BOGUE FALAYA PARK ADA IMPROVEMENTS

CITY OF COVINGTON, LOUISIANA

**ADDENDUM NO. 2**

DATE ISSUED: SEPTEMBER 28, 2020

GENERAL NOTES AND TYPICAL SECTIONS	
BOGUE FALAYA PARK CITY OF COVINGTON ST. TAMMANY PARISH, LOUISIANA	
PROJECT NO.	575-1701
DATE	JULY, 2020
SCALE	AS SHOWN
SHEET NO.	2a

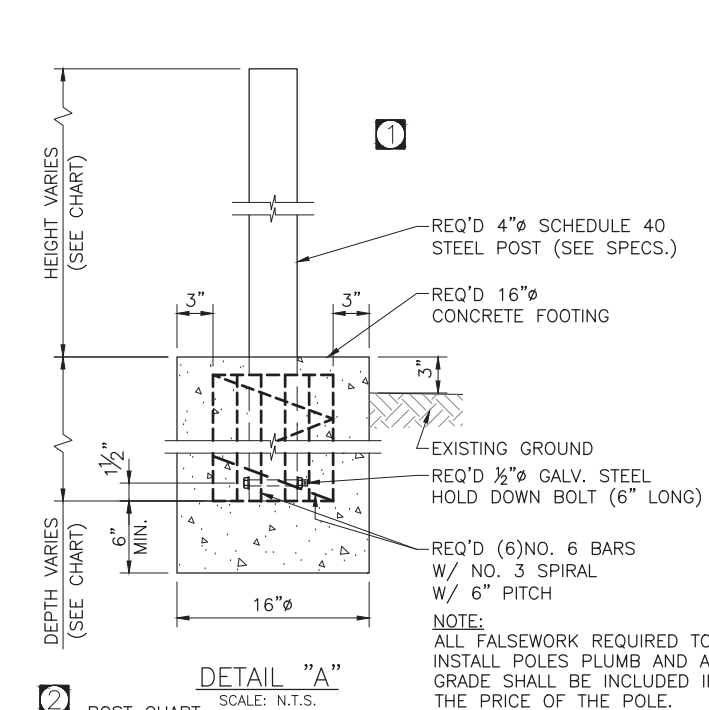
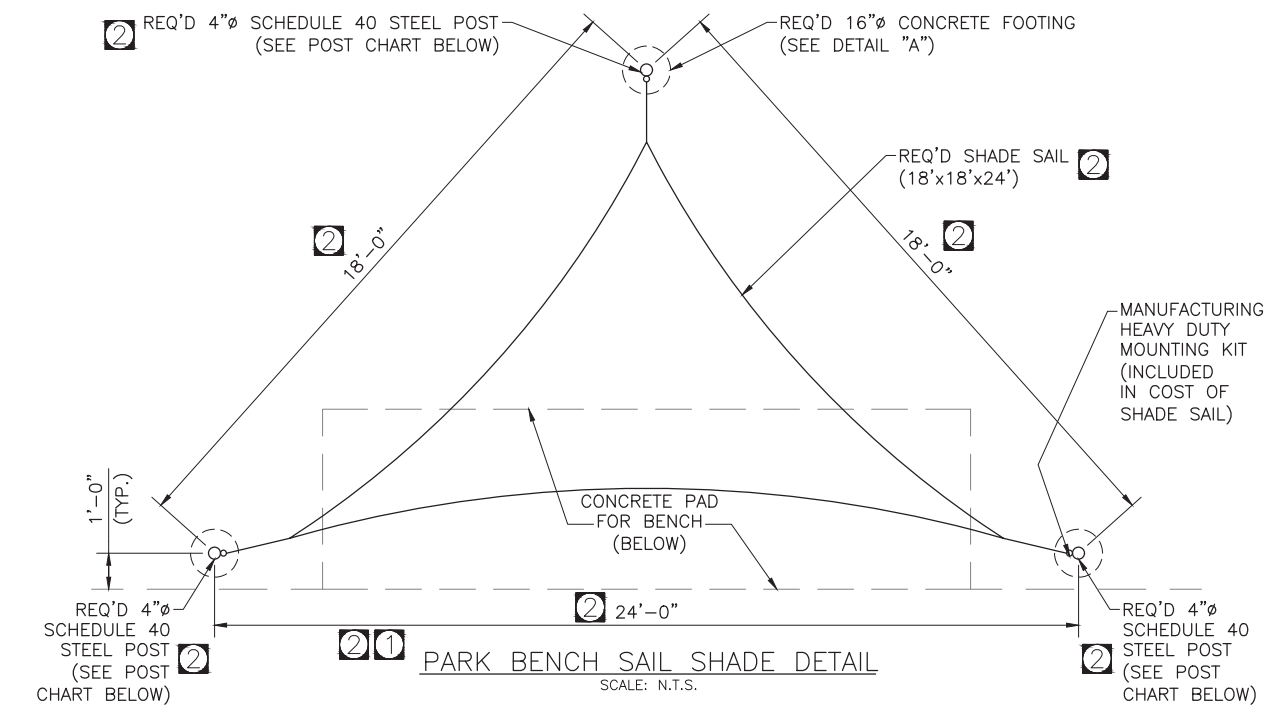
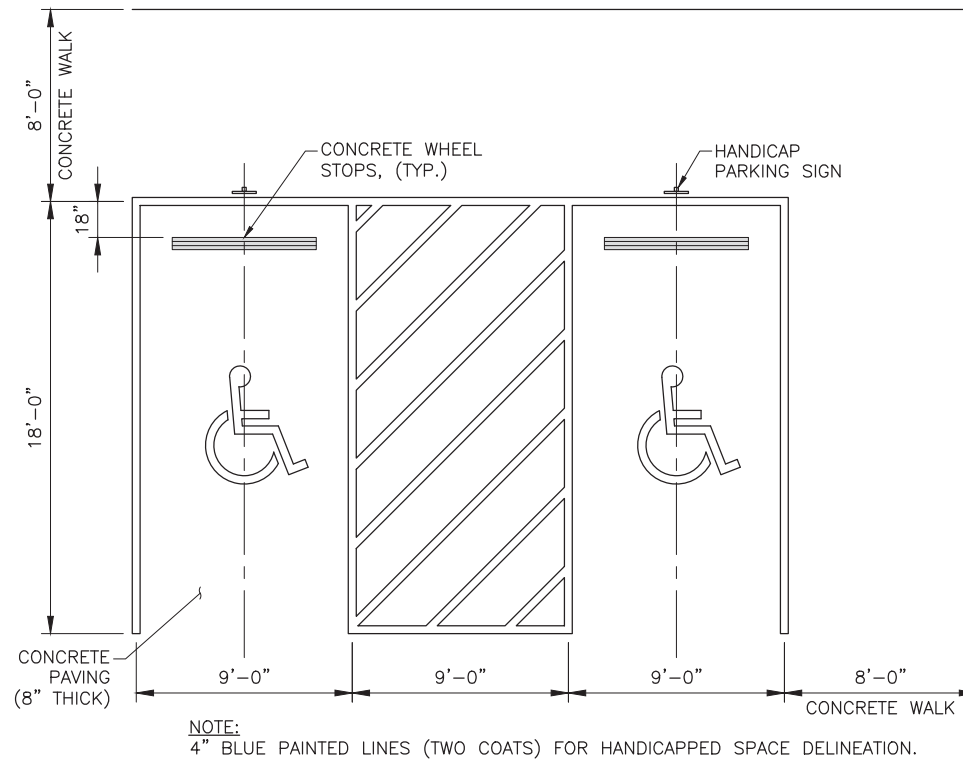
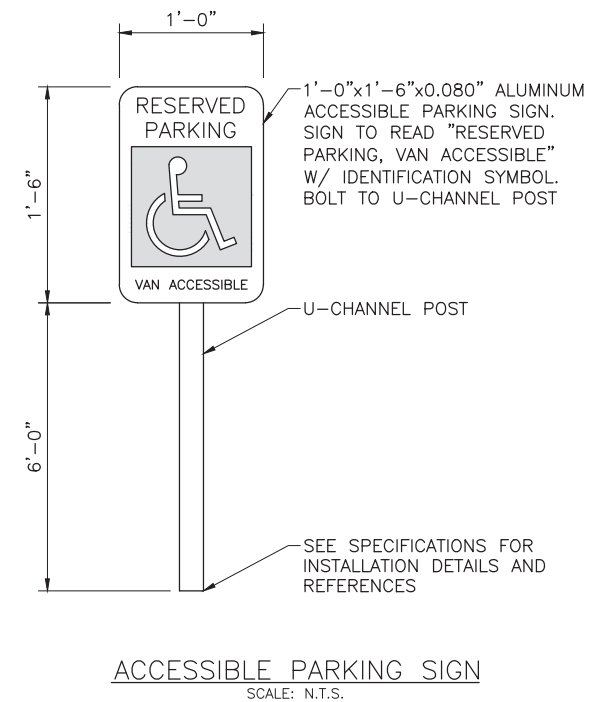
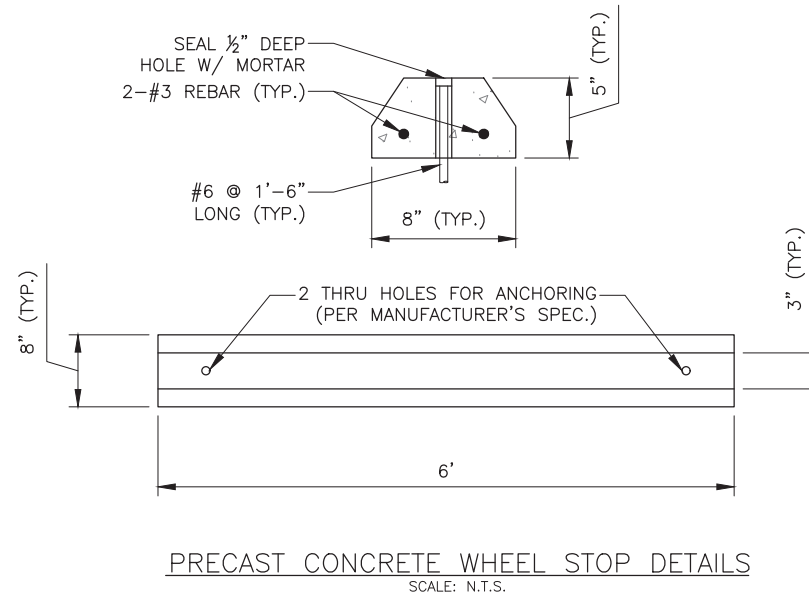
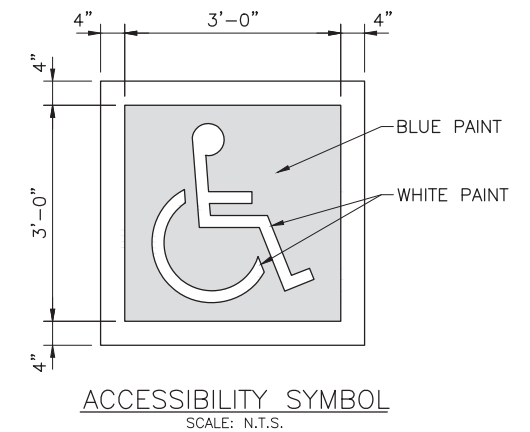
1. Sheet 2a and Sheet 3 of the drawing set have been revised and made part of this addendum #2.

REVISION		DATE	DESCRIPTION
01	09-24-20		BENCH AND SAIL SHADE DETAIL REVISION
02	09-28-20		SAIL SHADE DETAIL REVISION

ORIENTATION	HEIGHT	DEPTH
NORTHERN MOST	(1 POST): 12'-0"	6'-0"
SOUTHERN MOST	(1 POST): 8'-0"	4'-0"
OTHER	(1 POST): 10'-0"	5'-0"
